## Relevant Information for Central Sydney Planning Committee

**FILE:** D/2023/97 **DATE:** 28 March 2024

**SUBJECT:** Information Relevant To Item 5 – Development Application: 12A and 14-26 Wattle Street, Pyrmont – D/2023/97

**Attachment A.** Correspondence and Plans for the Rooftop Plant Area and Parapet Zone of Building C and Tree 40

**Figure 1:** Tree retention value plan showing trees recommended for retention by the City's Tree Management Unit

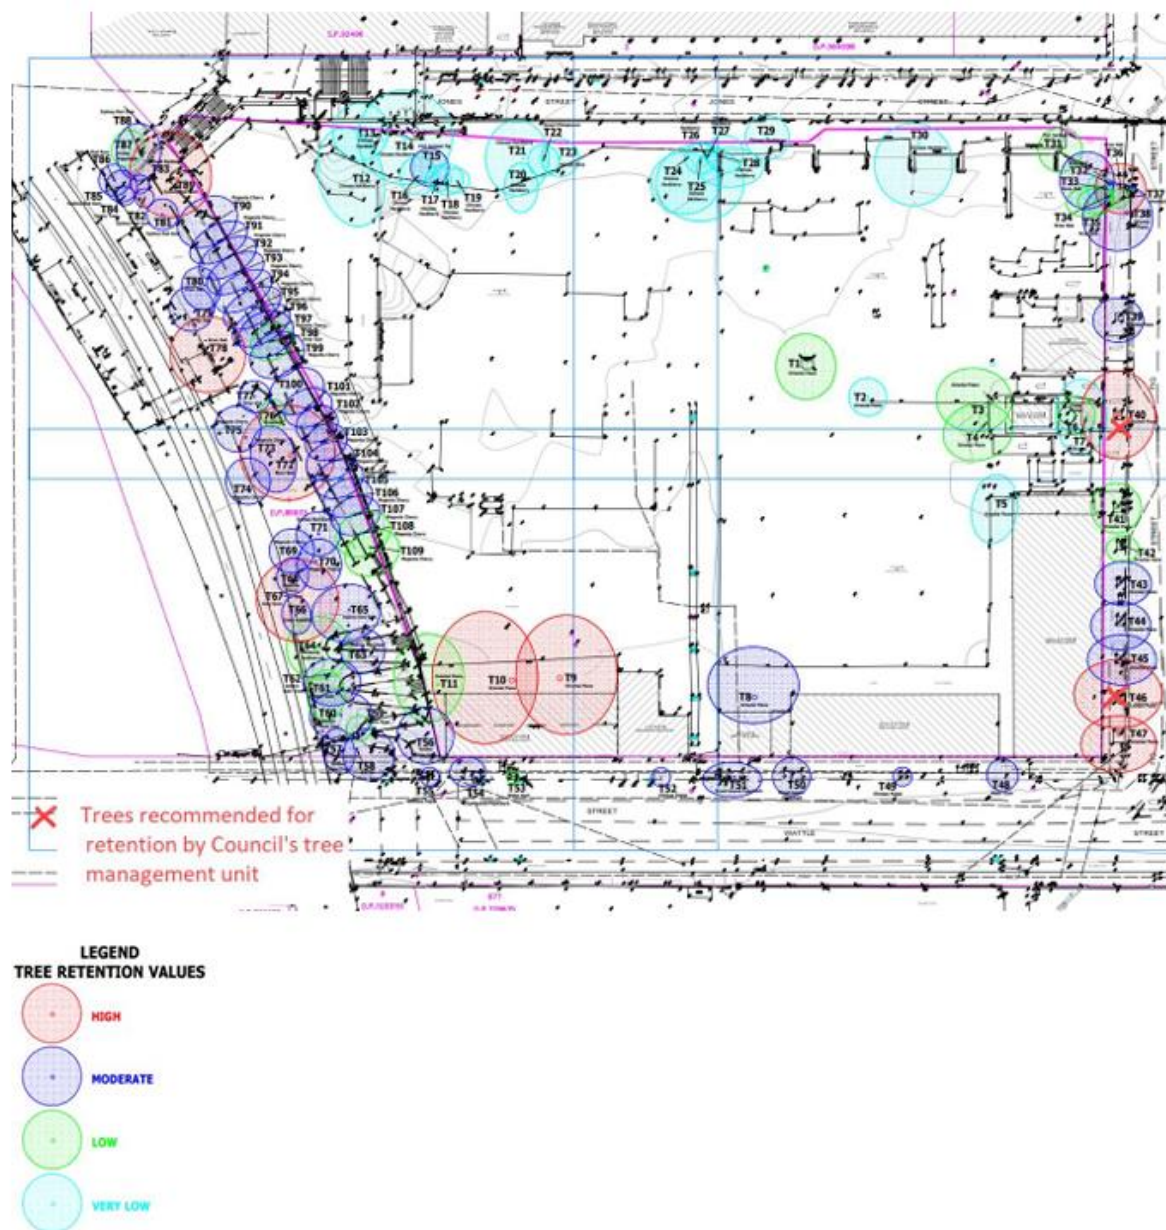
On 27 March 2024, correspondence was received from the applicant requesting that Tree 40, a *Platanus orientalis* Oriental Plane Street tree, on Fig Street, be approved for removal as the retention of this tree is an error (Conditions 44 – Trees Approved for Removal and 45 – Trees That Must Be Retained of Attachment B to the Central Sydney Planning Committee Report). The applicant has stated that Tree 40 is approved for removal in the concept development consent D/2019/649 (as amended).

The City's Tree Management Unit advised during the assessment of the development application that Tree 40 is part of a group of street trees on Fig Street that are considered to be prominent landscape elements.

However, Condition 31 – Street Trees and Detailed Design Application of D/2019/649 (the Concept Approval) approved the Arboricultural Impact Assessment Report prepared by Earthscape Horticultural Services, dated 3 September 2019, which recommended the removal of Tree 40. Further to this, subsequent Arborist reports provided by the applicant for D/2023/97 support the original recommendation to remove Tree 40.

Tree 40 (an oriental plane tree on Fig Street) was approved for removal in the concept development consent because of the impact on the TPZ (27%) pruning required by the Fig Street building (35% crown loss).

~~(a) Retain Tree 40 (Oriental Plane Tree)~~

(b) Retain Tree 46 (London Plane tree).

During the erection of scaffolding for Tree 40 and Tree 46, Council's Tree Management Officer and the Project Arborist are to inspect the trees prior to any pruning taking place to provide reach joint agreement on specific branches to be pruned and the points that the branches should be reduced to.

ISSUED TITLE  
 MECHANICAL SERVICES  
 HVAC - BUILDING C - ROOF  
 SECTIONS

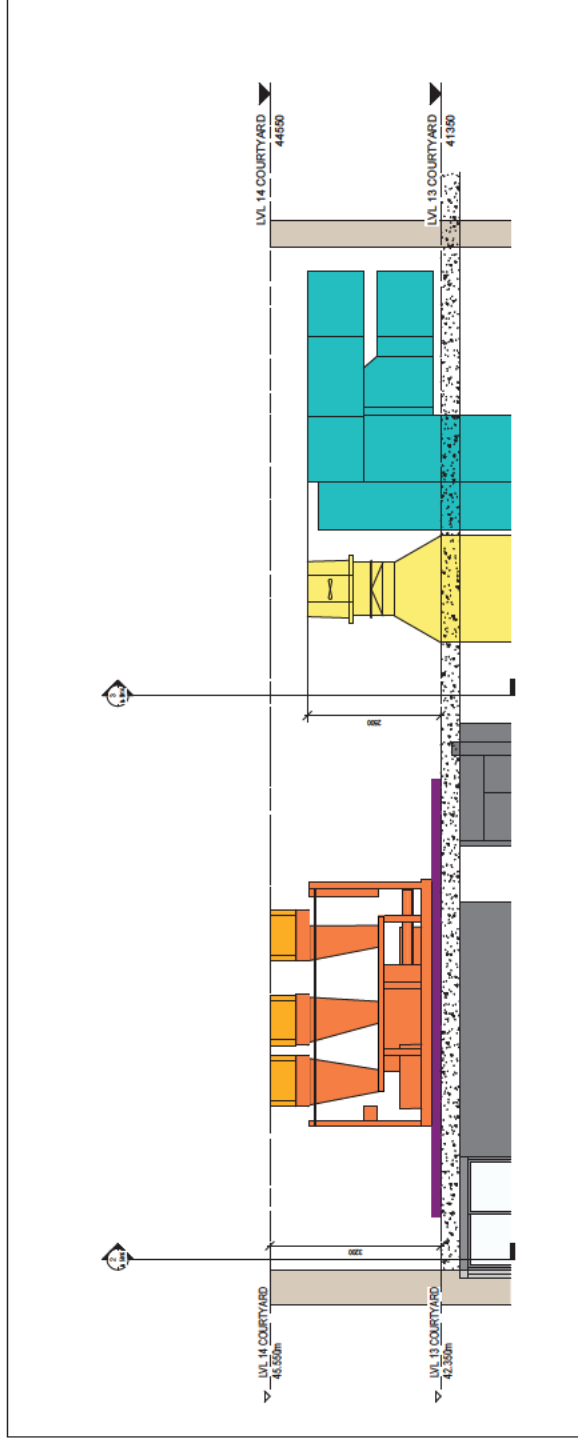
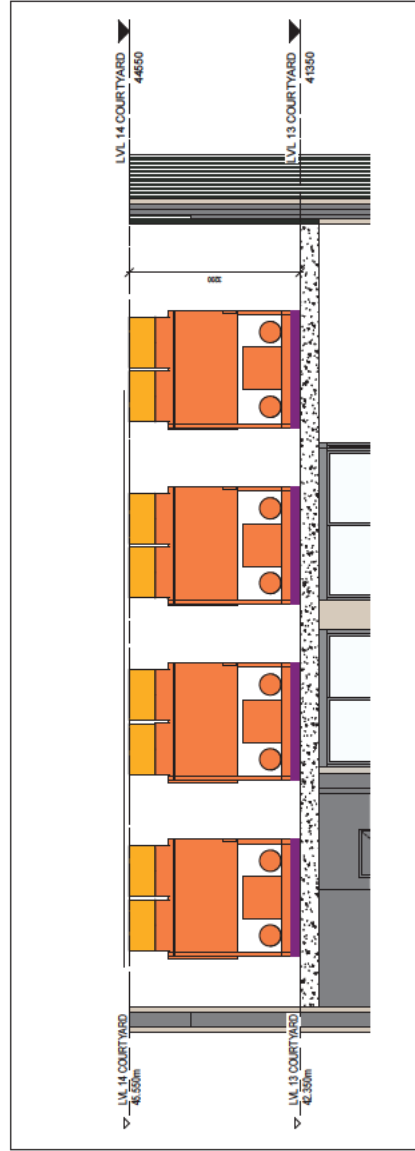
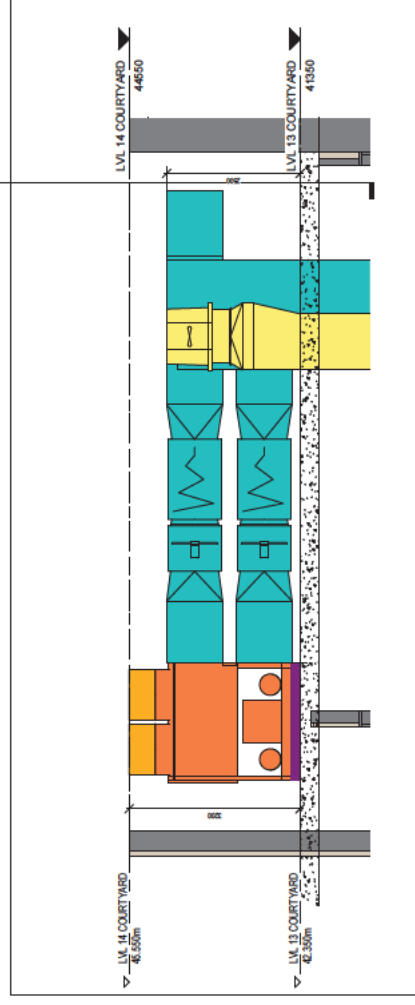
Please find attached the mechanical plans that were tabled at yesterday's meeting. As discussed at the meeting and illustrated in the mechanical drawings and details:

- The roof of the courtyard building is proposed to accommodate the air-cooled chillers that will service the entire development.
- The chillers require unobstructed access to the sky and cannot be located in a basement. Pumps and other mechanical plant that do not require air and sky access have been located in the basement.

- Alternate locations for the chillers were investigated including the roof of the Jones Street building, however, this was deemed unsatisfactory by the applicant and Council's planning experts because of the visual impact.

- The height of the rooftop plant enclosure (parapet) corresponds with the height of the chillers as illustrated in the additional plans and details.
- Any lowering of the parapet will expose the chillers to view and disrupt the building architecture.

- (i) RL ~~43.55~~ **45.55** (AHD) to the Plant Room Equipment and Parapet Zone
  - (ii) RL 42.35 (AHD) to the Level 12 roof
  - (iii) RL 39.45 (AHD) to the Level 09 parapet

ISOMETRIC VIEW 1

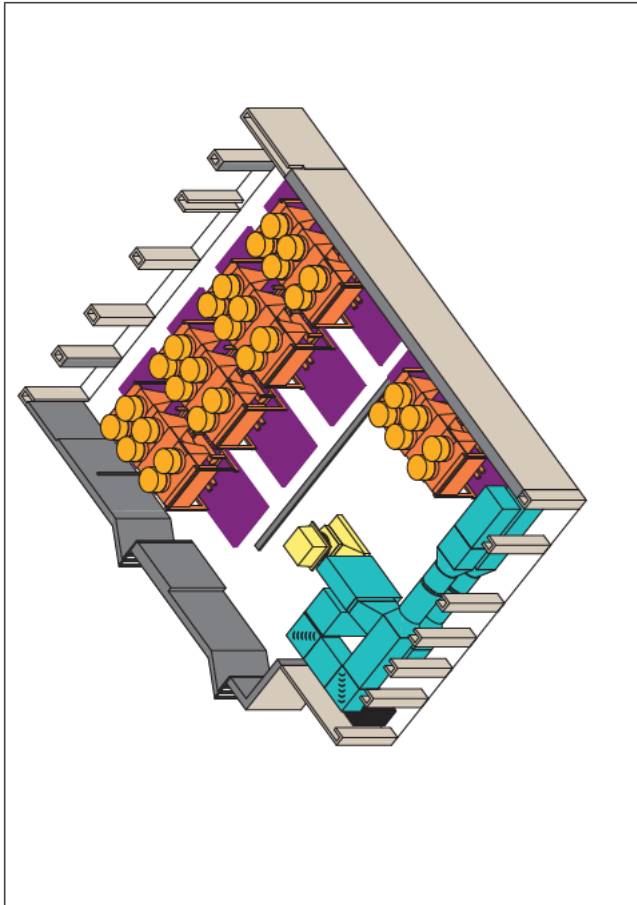
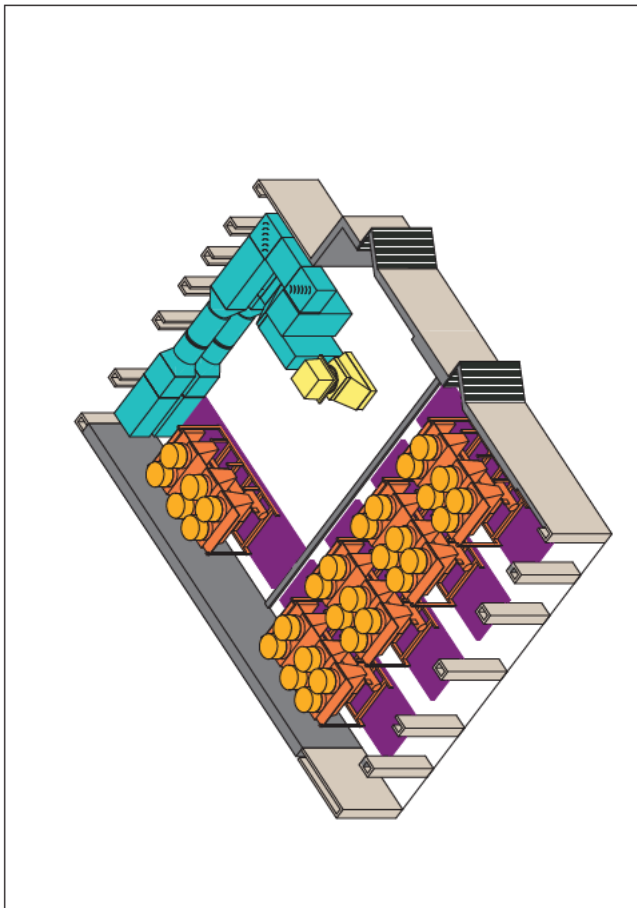
- a stair pressurisation system for each fire stairs core at a height of at least 2.5m;
- lobby relief (smoke exhaust) system at a height of at least 2.5m and separated from the stair pressurisation system at a minimum distance of 6m; and
- the air conditioning system/plant (5x off air cooled chillers) for the entire development at 3.2m in height.

All three types of mechanical systems are required to be open to the air, and the extrusion of the architecture to create a parapet zone, as currently proposed, acts to conceal the rooftop plant area. A 2m reduction of the parapet zone would expose the plant area. Further, relocation of the air conditioning system to the other buildings, particularly Jones Street, will result in visual impact.
